**SERVICE BULLETIN**

**WATER INLET COMPARTMENT**

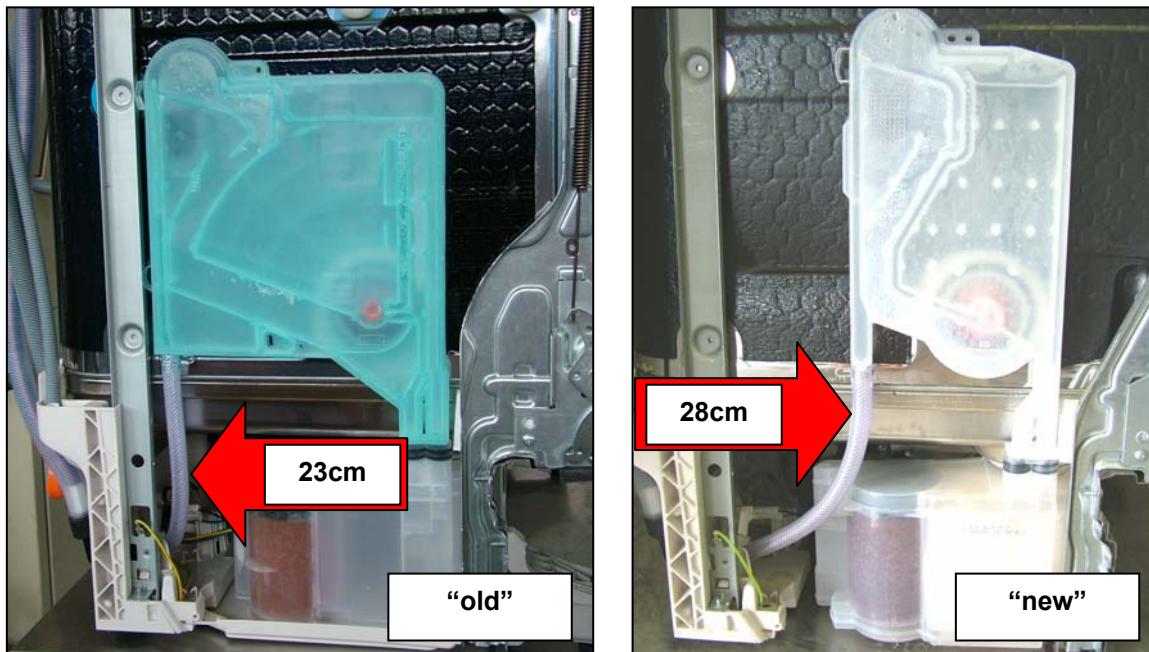
In the dishwashers produced in the Solaro (MI) factory, a new water inlet compartment will be gradually introduced with reduced dimensions and with a longer hose to connect the solenoid valve.

If, in case of intervention on appliances which feature the “new” compartment, the spare part received is the “old” compartment, it is necessary to cut the connection hose to the electric valve by a length of 23cm to avoid chokes or folds, as indicated in figure.

The two compartments are functionally fully interchangeable.
